Subject: Application for Renewal of NRC License SNM-1067

Description of Proposed Changes

SNM-1067
LICENSE RENEWAL APPLICATION
PARTS I & II

Figure 6-3

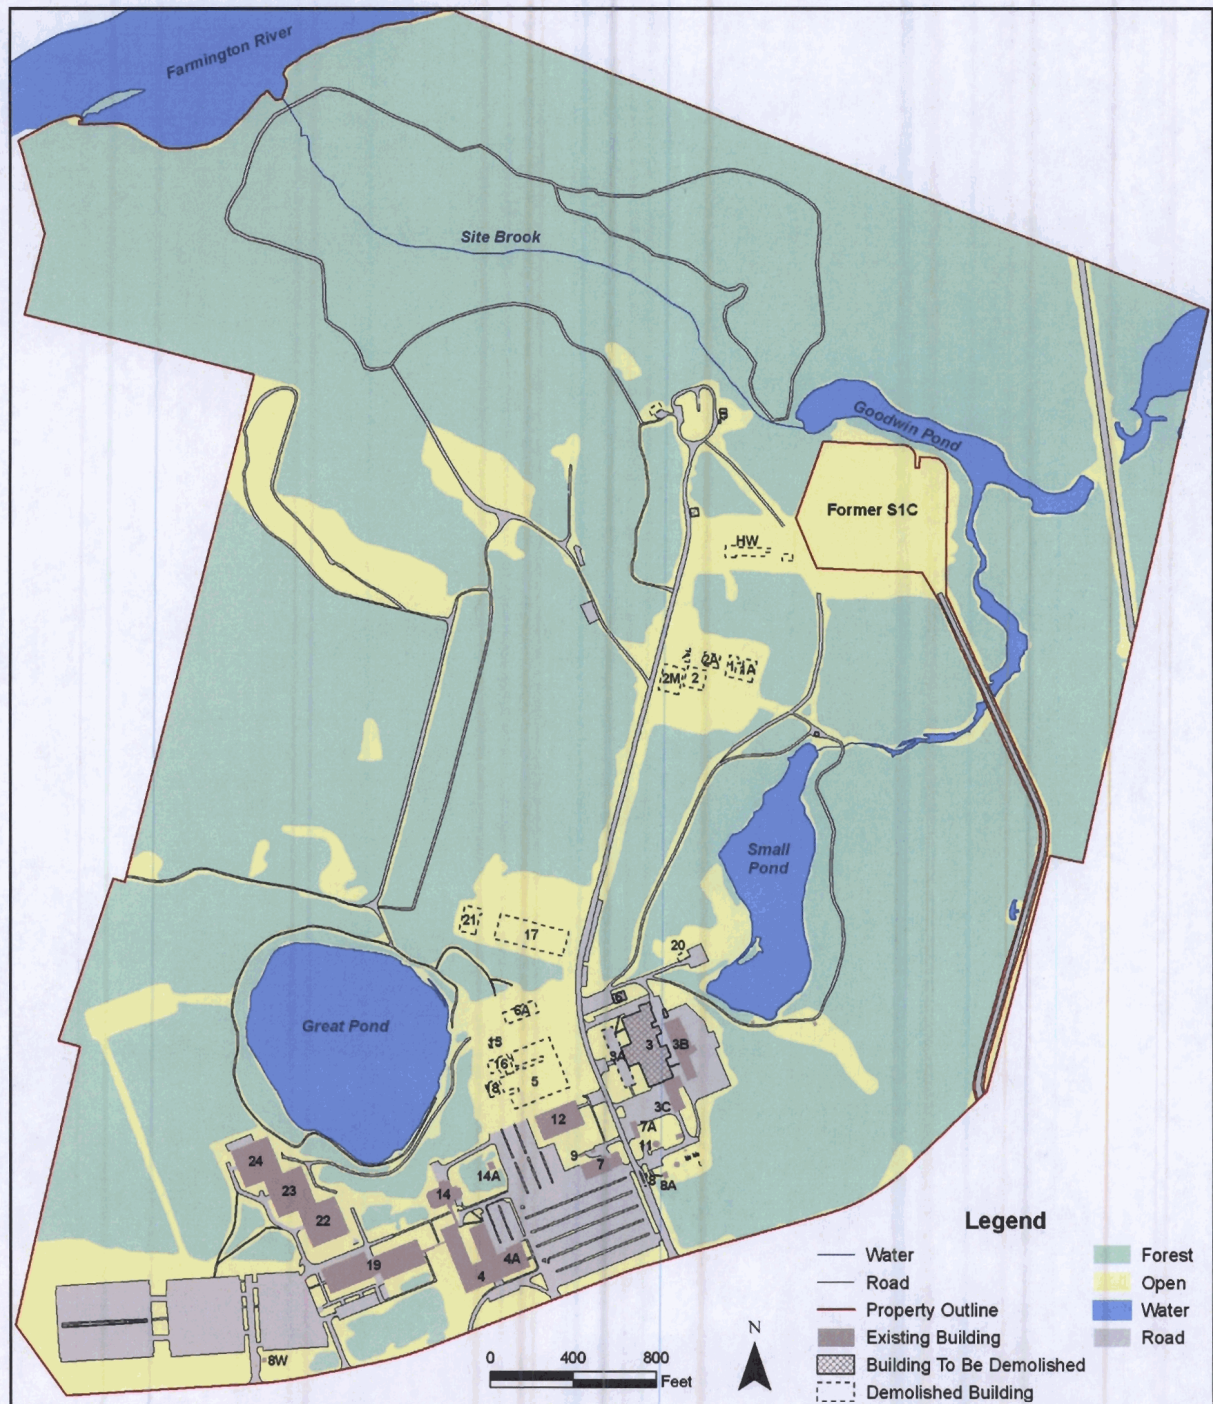
- Page 6-9, Figure 6-3: Updated the figure to revise the property boundary on the western side of the site.
